TVA-BFN-TS-409

April 15, 2003

BROWNS FERRY NUCLEAR PLANT (BFN) - UNITS 1, 2, AND 3 - TECHNICAL SPECIFICATIONS (TS) CHANGE 409 - ADOPTION OF TS TASK FORCE (TSTF) TRAVELER - 287, REVISION 5 - CONTROL ROOM VENTILATION SYSTEM ENVELOPE - ALLOWED OUTAGE TIME

Technical Specifications (TS) Change 409 Adoption of TSTF-287, Revision 5 Control Room Ventilation System Envelope Allowed Outage Time

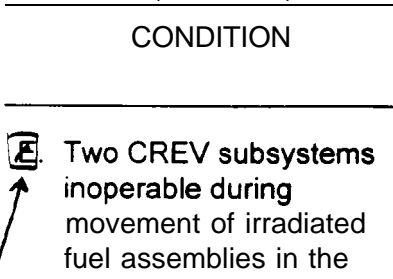
<p><input checked="" type="checkbox"/> Two CREV subsystems inoperable in MODE 1, 2, or 3.</p> <p>(E) → <input checked="" type="checkbox"/></p>	<p><input checked="" type="checkbox"/> 1 Enter LCO 3.0.3.</p>	<p>Immediately</p>

for reasons other than Condition B

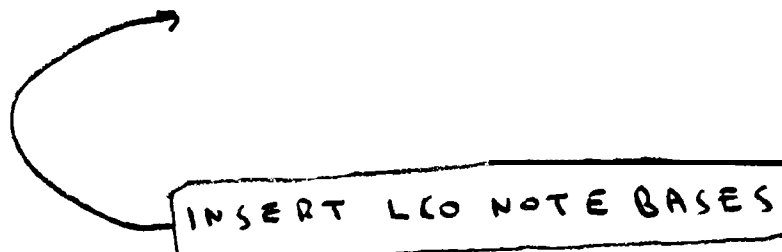
INSERT
LCO NOTE BASES ~~(BWR-4 3.7.4, MCREC System)~~

The LCO is modified by a Note allowing the main control room boundary to be opened intermittently under administrative controls. For entry and exit through doors **the** administrative control of the opening is performed by **the** person(s) entering or exiting the area For other openings, these controls consist of stationing a dedicated individual at **the** opening who is in continuous communication **with** the main control room. This individual will have a method to rapidly close the opening when a need for main control room isolation is indicated.
